**ESENCIA K-8 PORTABLES PHASE 2 PROJECT
Bid No. 2324-09**

**ADDENDUM NO. 2
May 6, 2024**

Subject: **ESENCIA K-8 SCHOOL
MODULAR CLASSROOMS**
Capistrano Unified School District

ADDENDUM No. 2

GRADING, PAVING AND
UTILITY PLAN
C-2.1

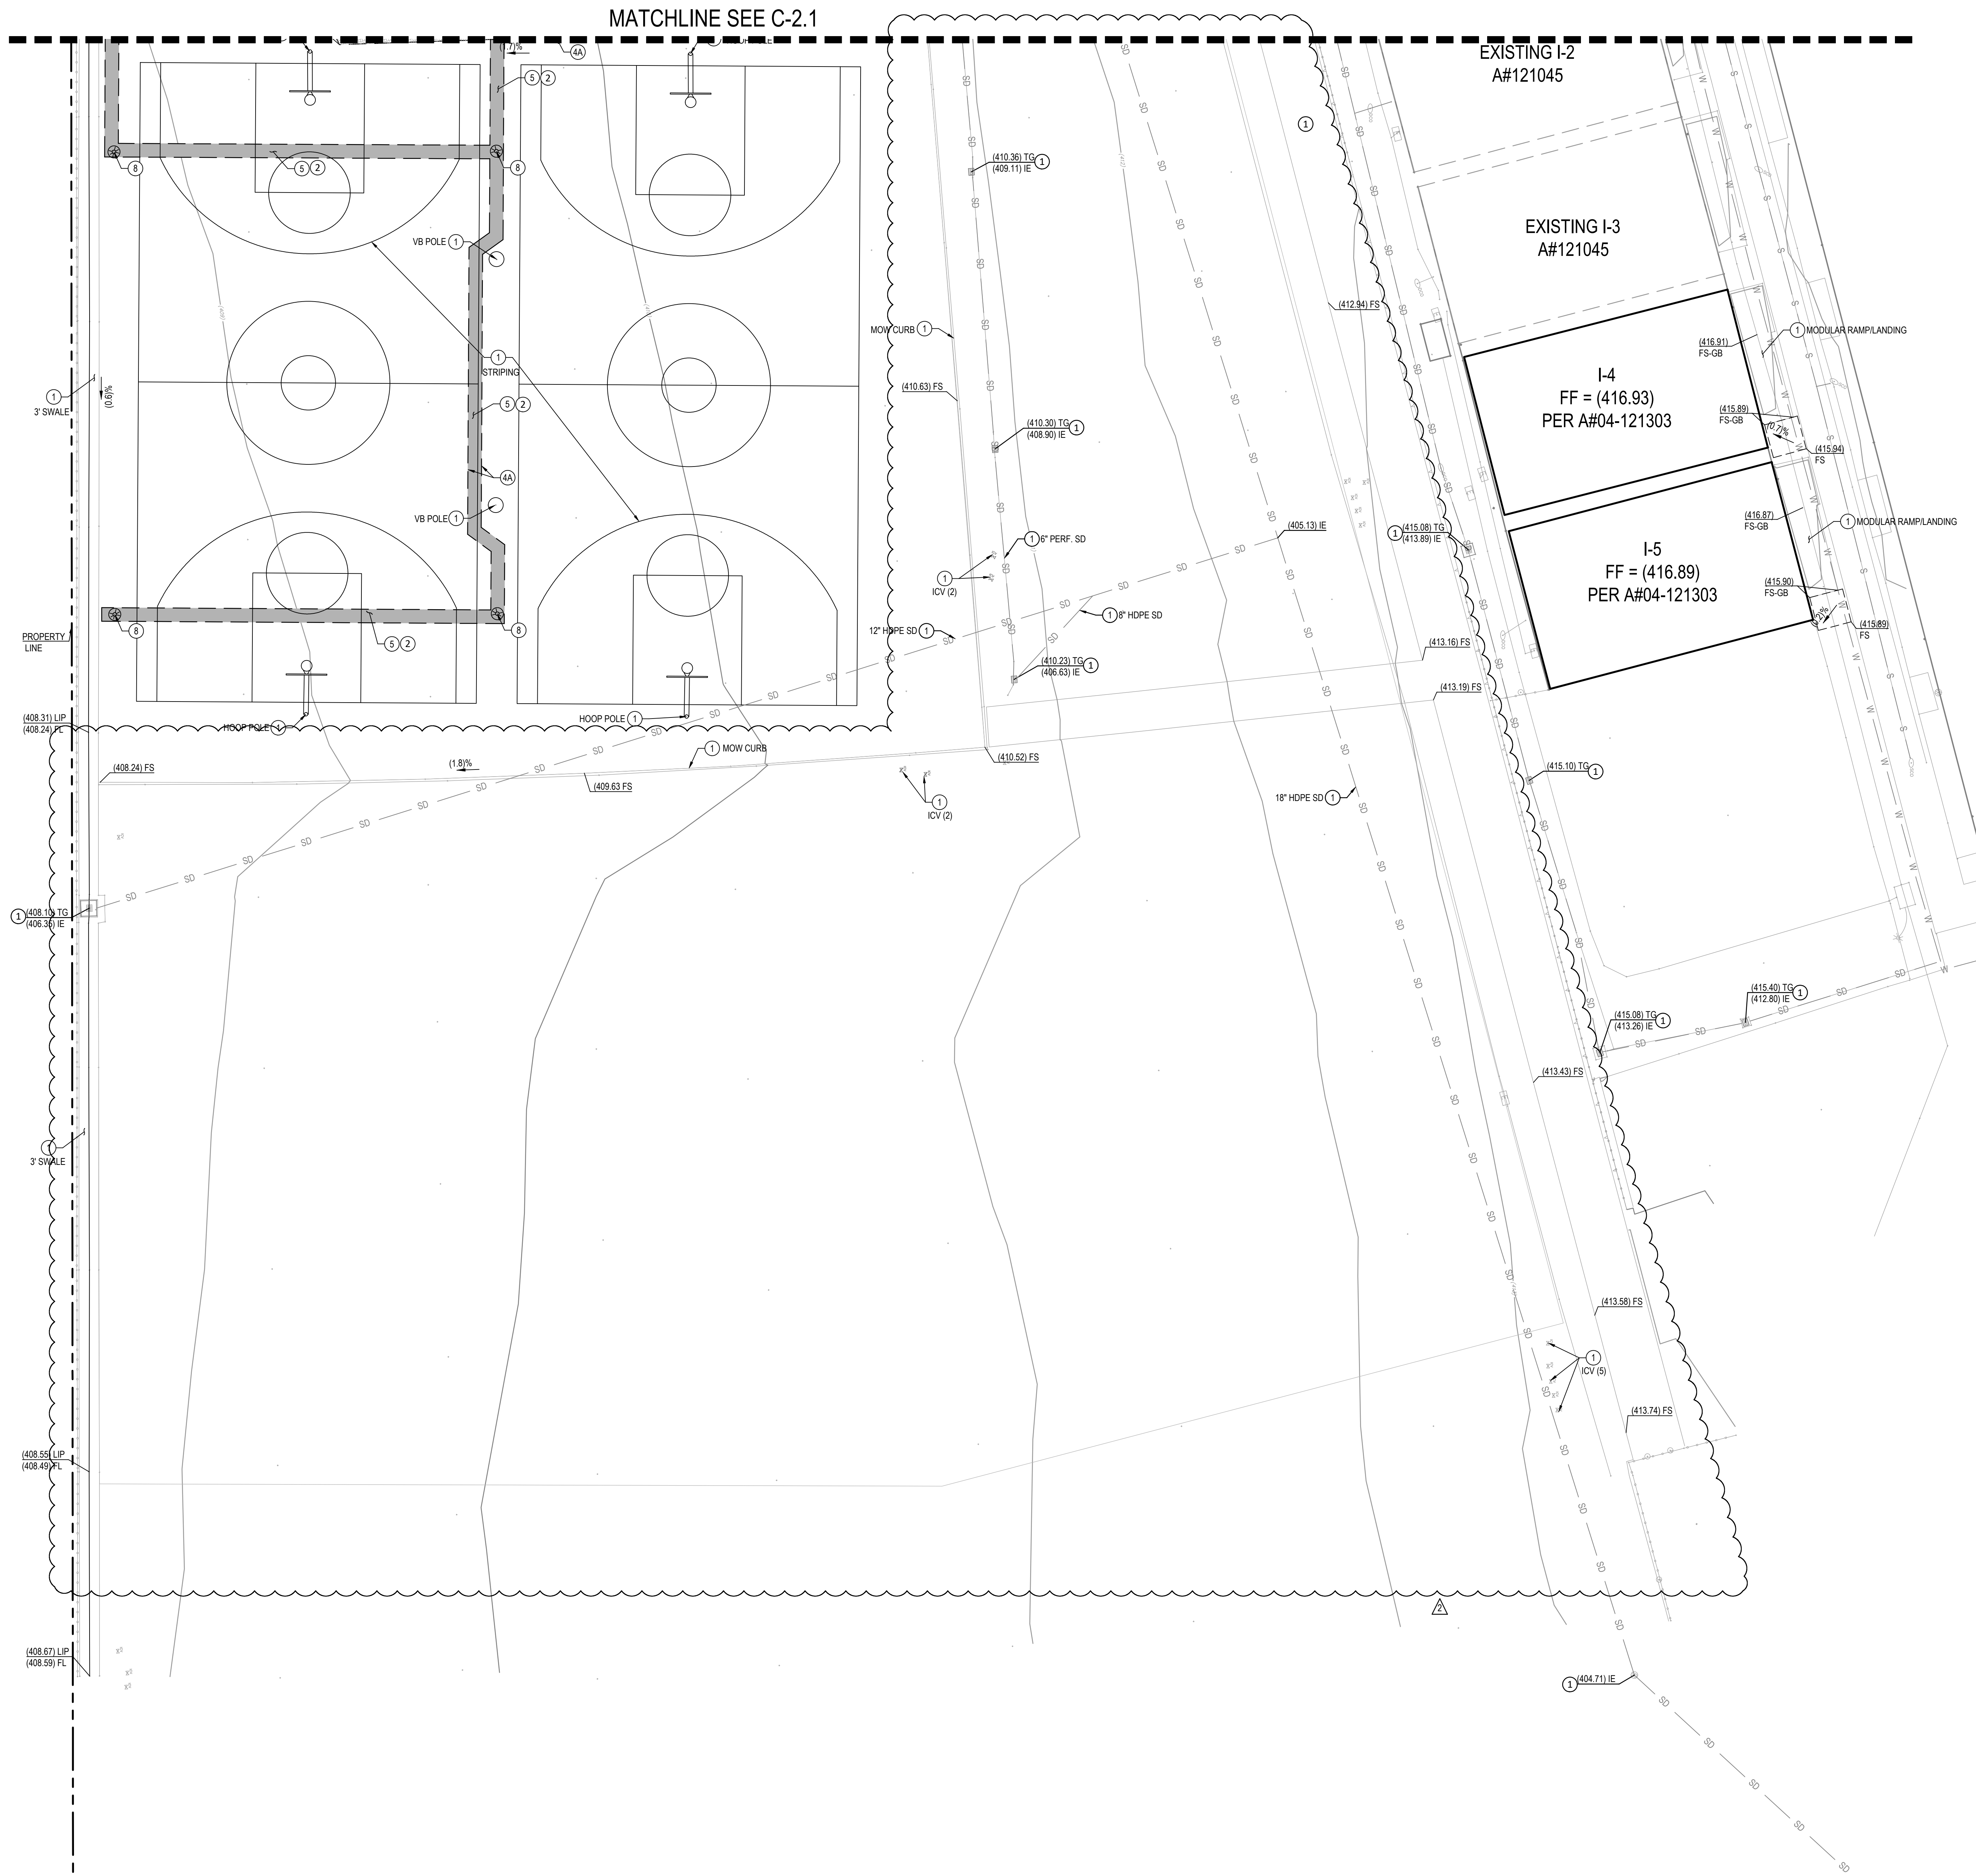
- A. At Storm Drain Data Table, delete No. 1 in it's entirety.
- B. Delete new asphalt paving (Construction Note #5) and "Future Modular Bldg"s immediately adjacent to Existing I-1 and Existing I-2. Existing construction within this area is to remain.
- C. At building J-4, Contractor shall extend all wet-utilities from the Points-Of-Connections (POC) as shown on this plan, to the POCs provided by the restroom building manufacturer on the adjacent plan-right / north end of the restroom building.

SITE DEMO PLAN - ENLARGED

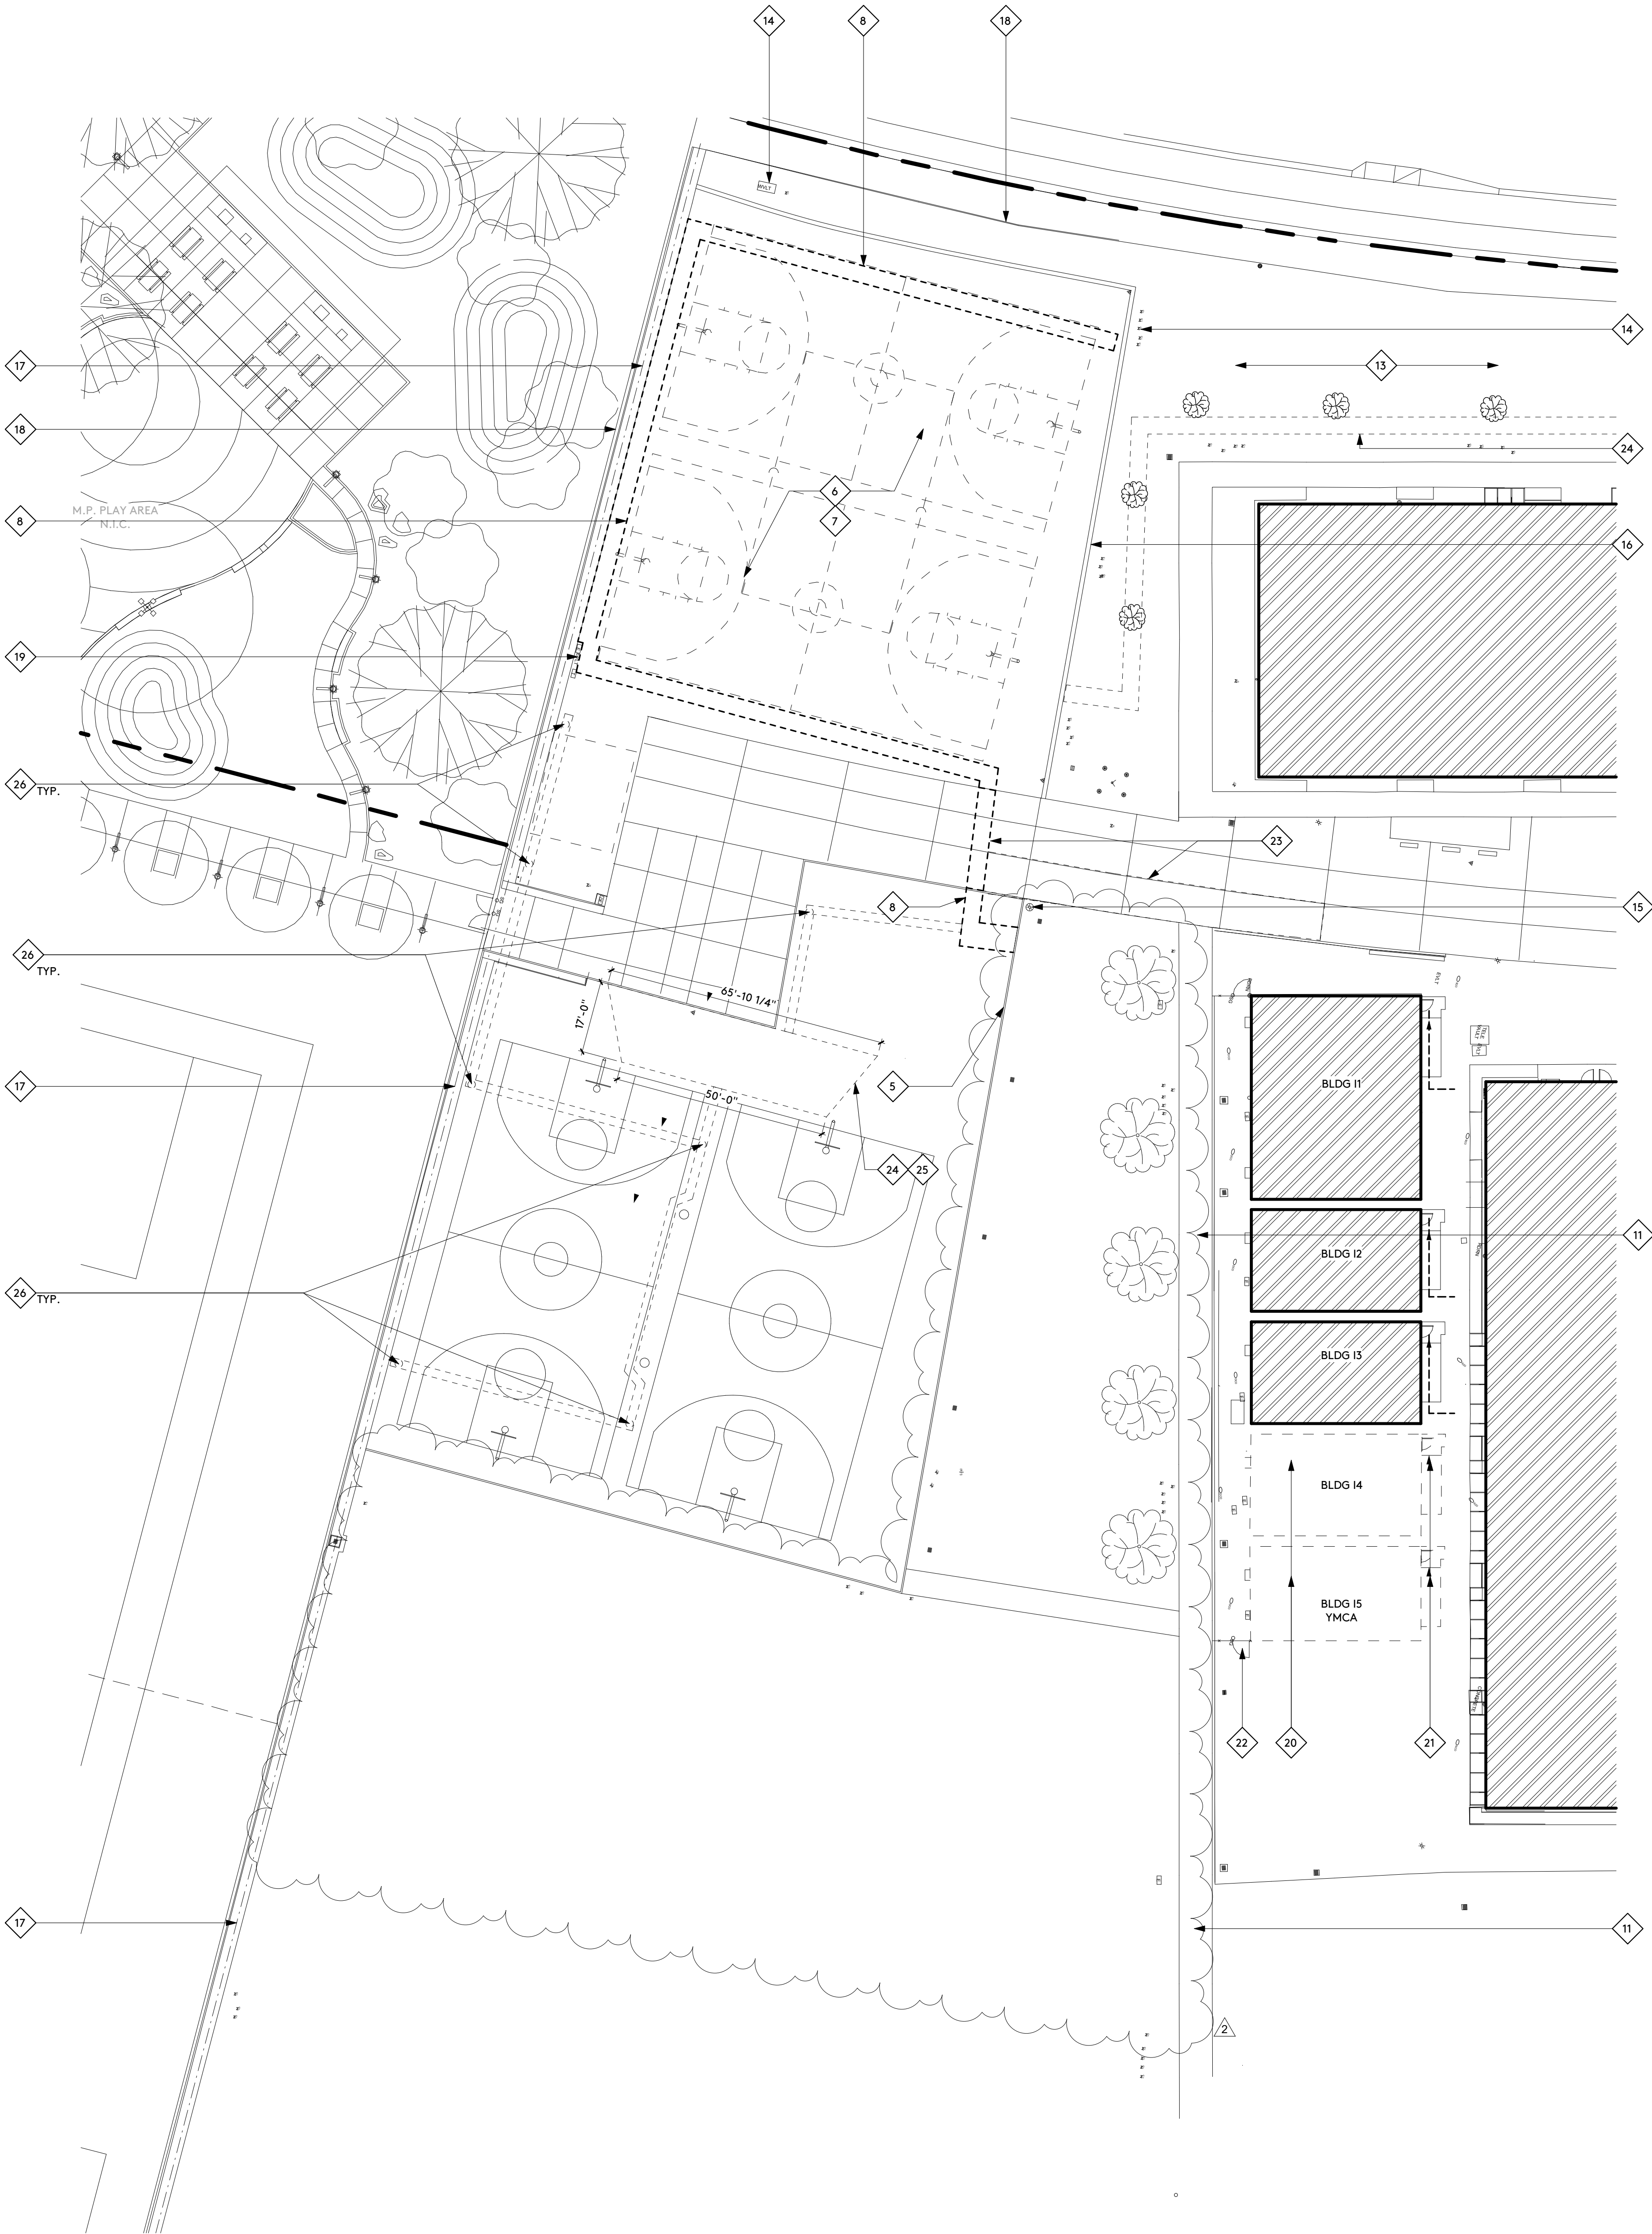
- A. At Demo Enlarged Plan Keynotes, replace keynotes #1 - #5 with new text "NOT USED". Refer to attached revised sheet A-1.1.
- B. At Site Demo Plan – Enlarged, delete demolition of existing planting and grass playfields south of existing Bldg I-1 through I-5, and east of existing asphalt paved basketball courts area. Delete demolition of existing concrete walkway at corner of existing asphalt paved basketball courts area. All existing construction in these areas is to remain.
